Access Compliance Report

Public Rights-of-Way

(Curb Ramps)

Intersection ID: 47816	Main Street: ROCKMOOR RIDGE RD	Cross Street: MISTY VIEW CT	Location: NW
ADA ID: 5DA06098E639	Ramp Type: Perp	Initial Pass/Fail: Fail	Overall Compliance: No Severity Score: 33.75

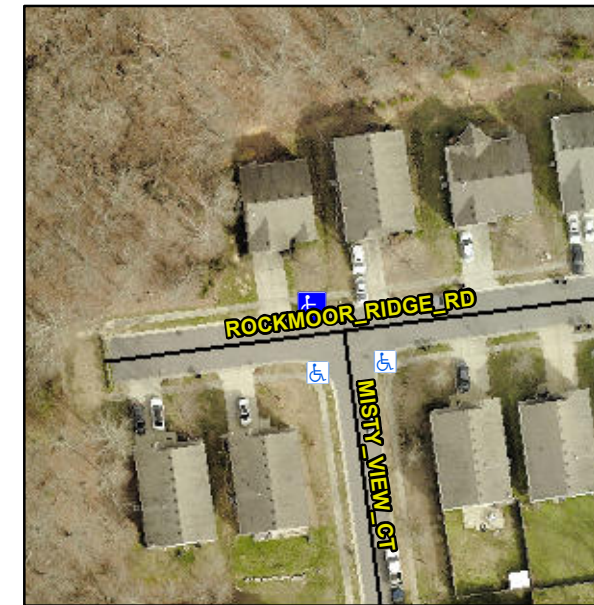
Not Found, R304.5.1, R304.2.2, R304.5.3

Compliance	Description	Data	Compliance	Description	Data
N/A	Ramp Length (in)	48.0	No	Ramp Slope (%)	9.8
No	Ramp Width (in)	47.5	No	Ramp XSlope (%)	5.1
N/A	Flare Type LT	N/A	N/A	Flare Type RT	N/A
N/A	Flare Slope LT (%)	N/A	N/A	Flare Slope RT (%)	N/A
N/A	Flare Traversable LT?	N/A	N/A	Flare Traversable RT?	N/A
N/A	Landing Length (in)	N/A	N/A	DWS Provided?	N/A
N/A	Landing Width (in)	N/A	N/A	DWS Contrast?	N/A
N/A	Landing Slope (%)	N/A	N/A	DWS Length (in)	N/A
N/A	Landing X Slope (%)	N/A	N/A	DWS Full Width?	N/A
N/A	Landing Curb? (Y/N)	N/A	N/A	DWS Offset (in)	N/A
N/A	Shared Landing?	N/A			
N/A	Gutter Ponding?	N/A	N/A	Gutter Slope (%)	N/A
N/A	Gutter Lip Ht (in)	N/A	N/A	Gutter X Slope (%)	N/A
N/A	Painted X Walk1?	No	N/A	Painted X Walk2?	N/A
	X Walk 1 Direction	To S		X Walk 2 Direction	N/A
N/A	X Walk 1 Width (in)	N/A	N/A	X Walk 2 Width (in)	N/A
	X Walk 1 Slope (%)	2.6		X Walk 2 Slope (%)	N/A
	X Walk 1 X Slope (%)	5.0		X Walk 2 X Slope (%)	N/A

Remove & Replace Entire Ramp.
